Castlelake Strategic Housing Development Environmental Impact Assessment Report (EIAR)

CCC Opinion and Minutes

Comhairle Contae Chorcaí Cork County Council

FOR: Planning Permission for the construction of a Strategic Housing Development of 706 no. residential units (239 no. houses and 467 no. apartments), crèche and associated site works at Castlelake, Terrysland, Carrigtwohill, Co. Cork.

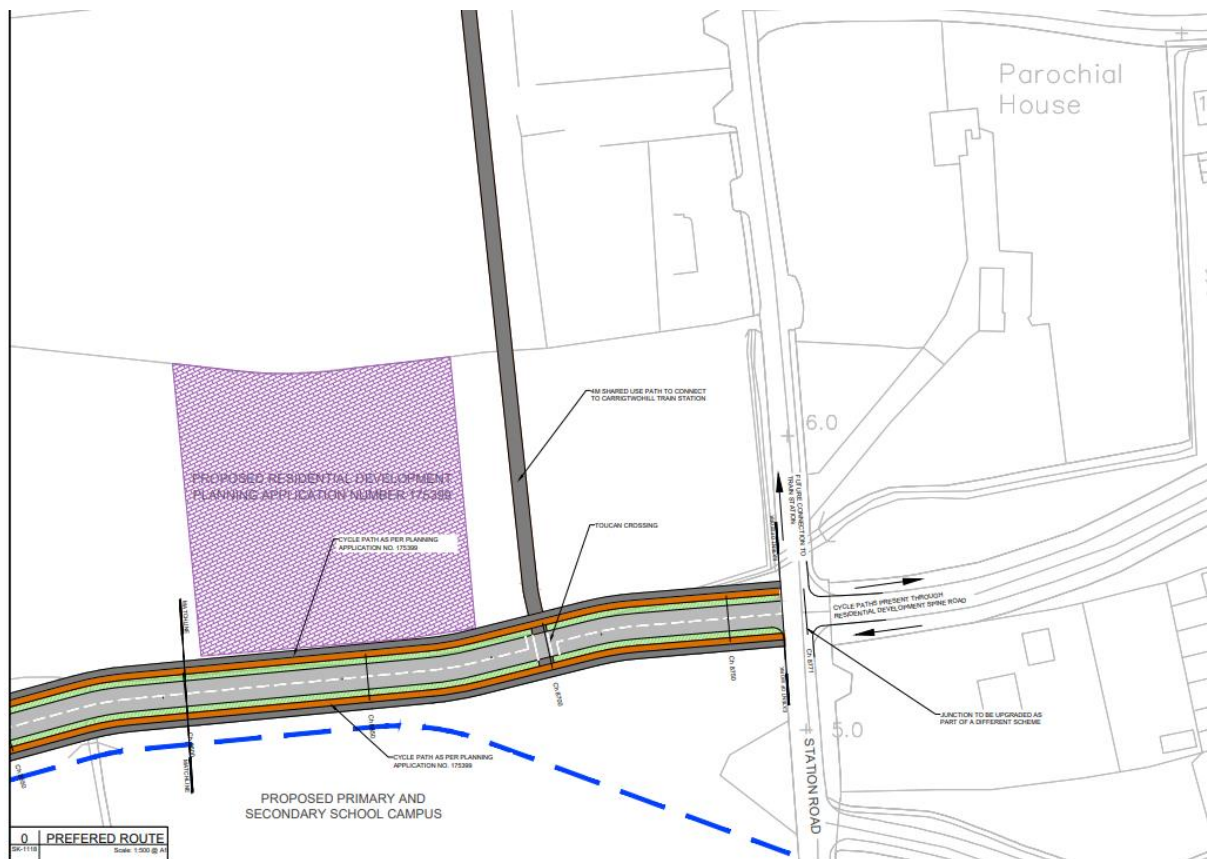
The applicant's proposed northbound cycle track on the west side of north-south link road (Blandcrest Main Road 1) terminates abruptly.

There are multiple accesses proposed to the Schools Link roads which would downgrade the pedestrian and cycle facilities. These may need to be reduced to maintain the standard of the sustainable transport measures (Schools Link Roads' pedestrian/ cycle facilities).

The connectivity of the scheme to Carrigtwohill Train Station appears to be dependent on the permitted Bury's Bridge Part 8, currently advertised Part 8 scheme and/or potential future planning applications. No direct connection appears to be proposed to the train station.
